BEFORE THE PUBLIC SERVICE COMMISSION OF UTAH

IN THE MATTER OF THE)	DOCKET NO. 17-035-39
VOLUNTARY REQUEST OF ROCKY)	DPU Exhibit 2.0 Dir
MOUNTAIN POWER FOR THE)	Testimony and Exhibits
APPROVAL OF RESOURCE)	Daniel Peaco
DECISION TO REPOWER WIND)	
FACILITIES)	
)	
)

Daniel Peaco

On Behalf of the Division of Public Utilities

Figure 1. Project impact on 20-year risk-adjusted PVRR(d) results, Medium Gas, Medium CO₂ case

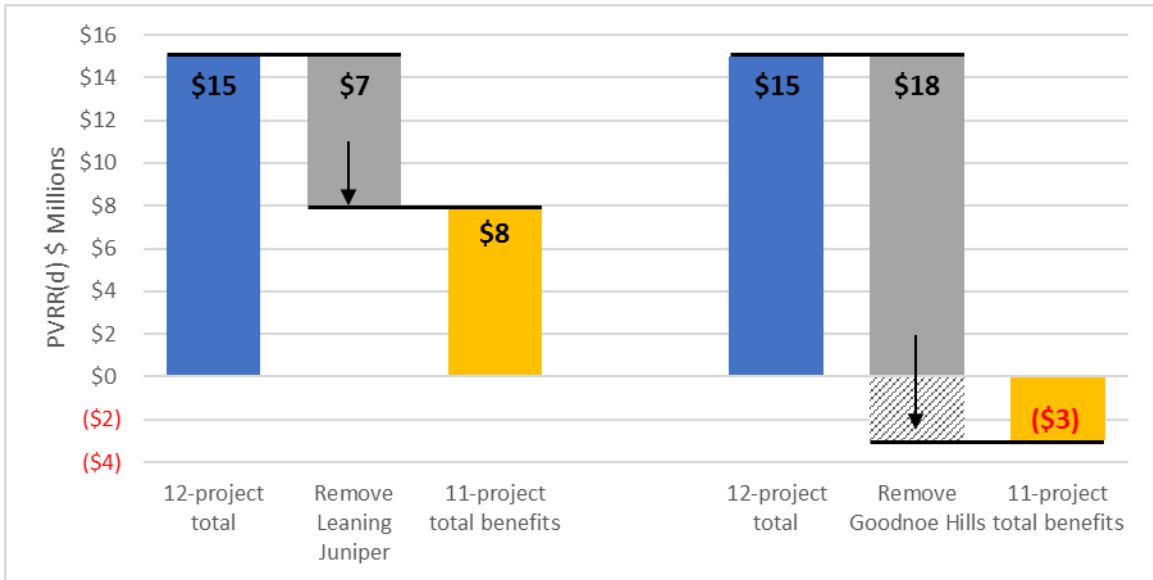
345 A. The total risk-adjusted PVRR benefits for all 12 projects (including Leaning Juniper and
346 Goodnoe Hills) total \$15 million in the Medium Gas, Medium CO₂ case.³⁴ The
347 comparison of total benefits to the benefits of each project is summarized in Figure 1.

This analysis demonstrates the importance of a project-by-project analysis to determine which, if any, of the repowering projects are in the best interest of customers and provide net benefits under a range of futures. Only with that analysis can the Commission make an informed decision on each of the repowering projects.
